Access Compliance Report

Public Rights-of-Way

Intersection ID: 29551	Main Street: WHITEHALL_PARK_DR	Cross Street: ARCO_CORPORATE_DR	Location: NE
ADA ID: 20416F0C9903	Ramp Type: Combination1Diag	Initial Pass/Fail: Fail	Overall Compliance: No
		Severity Score: 0

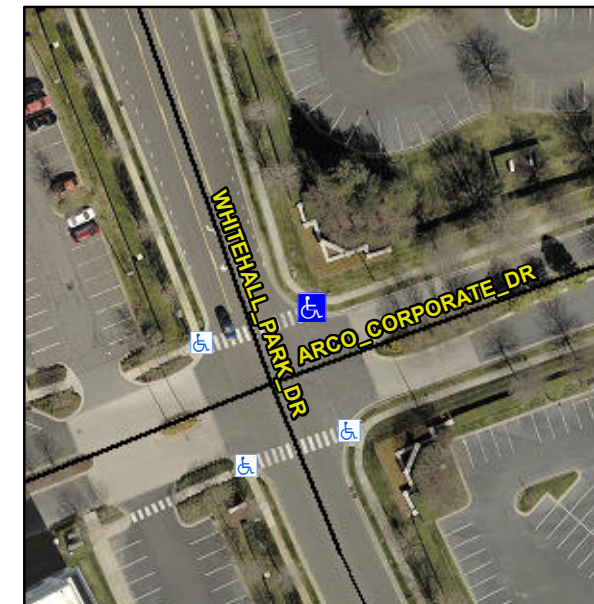
R304.5.1, R304.5.1, R304.2.2, R304.5.3, R304.3.2

Compliance	Description	Data	Compliance	Description	Data
N/A	Ramp Length LT (in)	69.0	N/A	Ramp Length RT (in)	67.0
No	Ramp Width LT (in)	46.0	No	Ramp Width RT (in)	47.0
No	Ramp Slope LT (%)	13.7	Yes	Ramp Slope RT (%)	5.3
Yes	Ramp XSlope LT (%)	0.2	No	Ramp XSlope RT (%)	8.9
N/A	Ramp Length (in)	47.0	No	Ramp Slope (%)	12.0
No	Ramp Width (in)	43.0	No	Ramp XSlope (%)	8.4
N/A	Flare Type LT	N/A	N/A	Flare Type RT	N/A
N/A	Flare Slope LT (%)	N/A	N/A	Flare Slope RT (%)	N/A
N/A	Flare Traversable LT?	N/A	N/A	Flare Traversable RT?	N/A
N/A	Landing Length (in)	N/A	N/A	DWS Provided?	N/A
N/A	Landing Width (in)	N/A	N/A	DWS Contrast?	N/A
N/A	Landing Slope (%)	N/A	N/A	DWS Length (in)	N/A
N/A	Landing X Slope (%)	N/A	N/A	DWS Full Width?	N/A
N/A	Landing Curb? (Y/N)	N/A	N/A	DWS Offset (in)	N/A
N/A	Shared Landing?	N/A			
N/A	Gutter Ponding?	N/A	N/A	Gutter Slope (%)	N/A
N/A	Gutter Lip Ht (in)	N/A	N/A	Gutter X Slope (%)	N/A
N/A	Painted X Walk1?	Yes	N/A	Painted X Walk2?	No

Remove & Replace Curb Ramp With Two New Directional Ramps or Equivalent.
